FROM: Peter Johansson  
TO: T10 SBP-3 working group  
DATE: April 23, 2001  
RE: Stream command block ORB

### 5.1.2.2 Stream command block ORB

**Figure 17 – Stream command block ORB**

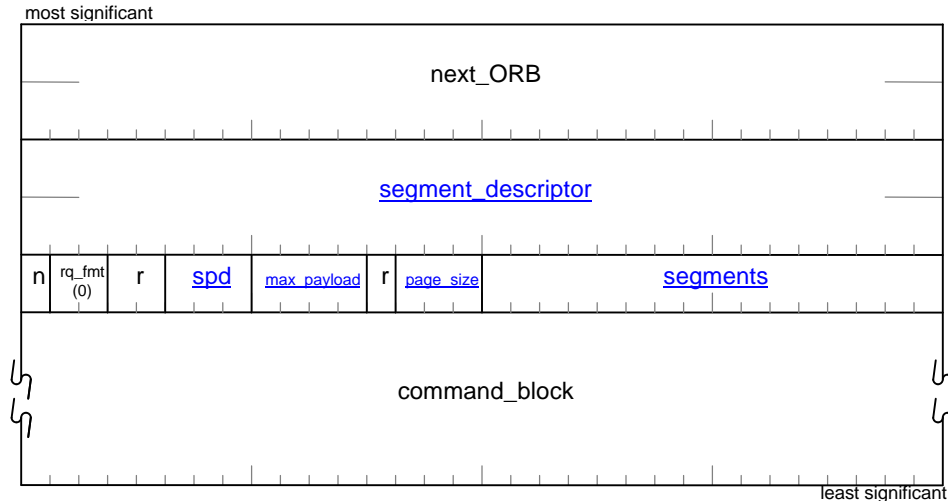
The format of the stream command block, as described in SBP-3 Revision 1a, was developed roughly five years ago and reflected then current thinking. It is, perhaps, in need of some revision to benefit from the experience gained in the intervening years, in particular with respect to AV disks.

The ORB as defined today may be used to construct a "play list" that stitches together discontinuous AV segments for seamless presentation to a viewer—but it does so in a bulky, awkward fashion. A single ORB is required to describe each contiguous segment, so the play list itself is a linked list of ORBs.

What if the play list were represented more compactly, in a single buffer?

The pages that follow contain proposed modifications to the SBP-3 draft to make this possible. Please note that new commands would be created in order to take advantage of this feature. Existing device-dependent commands were designed without knowledge of a play list.

The *next\_ORB* field shall contain a null pointer or the address of a dummy ORB or a stream command block ORB and shall conform to the address pointer format illustrated by Figure 12.

The *segment\_descriptor* field shall contain either an immediate segment descriptor or the address of an array of segment descriptors. The format of segment descriptors is specified by Figure 17a. When *segments* is zero, an immediate segment descriptor is present in the ORB. Otherwise, Figure 11 shall specify the format of the *segment\_descriptor* field which shall address a contiguous array of segment descriptors.

[The spd field shall specify the maximum speed that the target may use for data transfer transactions addressed to the segment descriptor array, as encoded by](#) **Error! Reference source not found.**

[The largest data transfer length that may be requested by the target in a single Serial Bus read or write transaction addressed to the segment descriptor array is  \$2^{\text{max\\_payload}+2}\$  bytes. The max\\_payload field shall specify a maximum data transfer length less than or equal to the length permissible at the data transfer rate specified by spd.](#)

[The page size field shall specify the underlying page size of the segment descriptor array memory. A page\\_size value of zero indicates that the underlying page size is not specified. Otherwise the page size is  \$2^{\text{page\\_size}+8}\$  bytes.](#)

[The segments field shall either be zero or contain the number of elements in the segment descriptor array addressed by stream descriptor. When the value of the segments field is zero, the ORB does not reference a segment descriptor array and the contents of the spd, max\\_payload and page\\_size field are unspecified.](#)
